ADDENDUM NO. 1

PROJECT NAME: SAPP Recreation Facility Renovation
UNL PROJECT NUMBER: C000P003
BID INVITATION NUMBER: 2301-14-7200

CONSULTANT: RDG Planning & Design
ADDRESS: 900 Farnam on the Mall, Suite 100
Omaha, NE 68102-5089

DATE OF ISSUANCE: February 6, 2014
DATE OF BID OPENING: Thursday, February 13, 2014
2:00 PM CT

2011.181.00
 35.01
 SDA-001

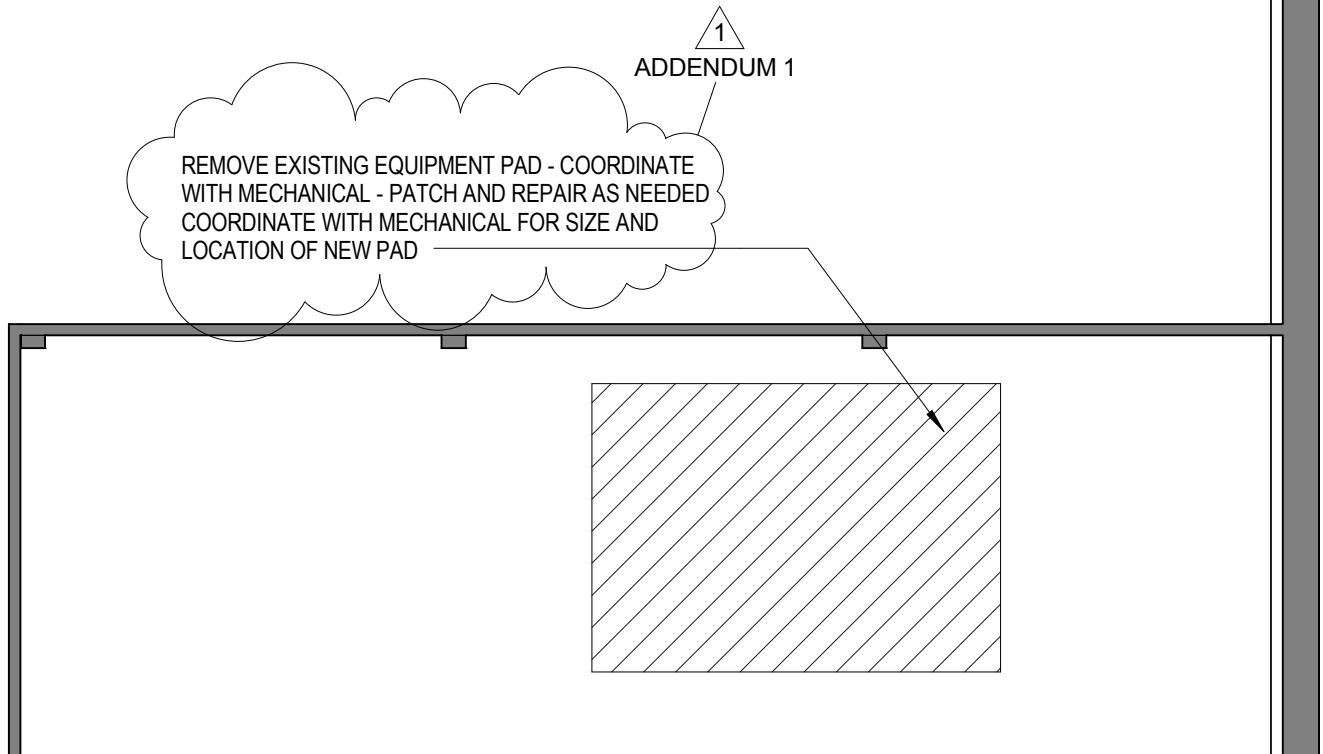
1GD-1 Sheet G00.01: Revise per attached Supplemental Drawing SDA-001.

2011.181.00
 35.01
SDA-002

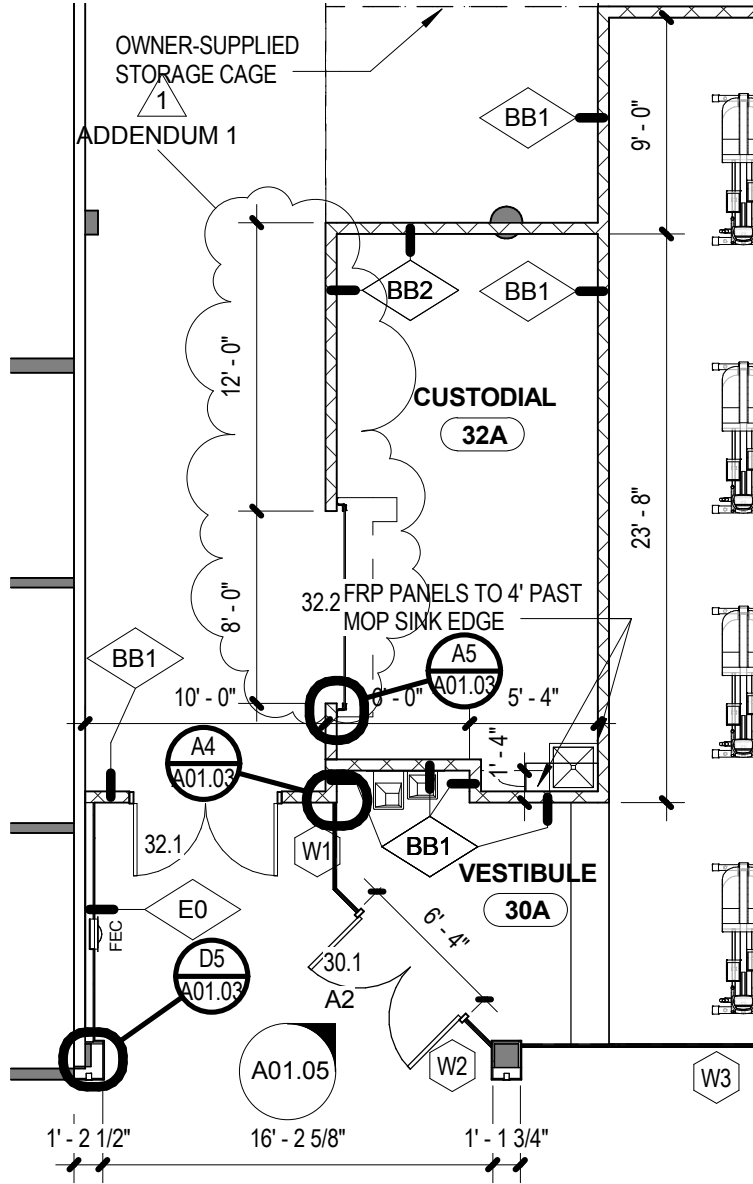
1GD-2 Sheet AD0.01:

A. Revise per attached Supplemental Drawing SDA-002.
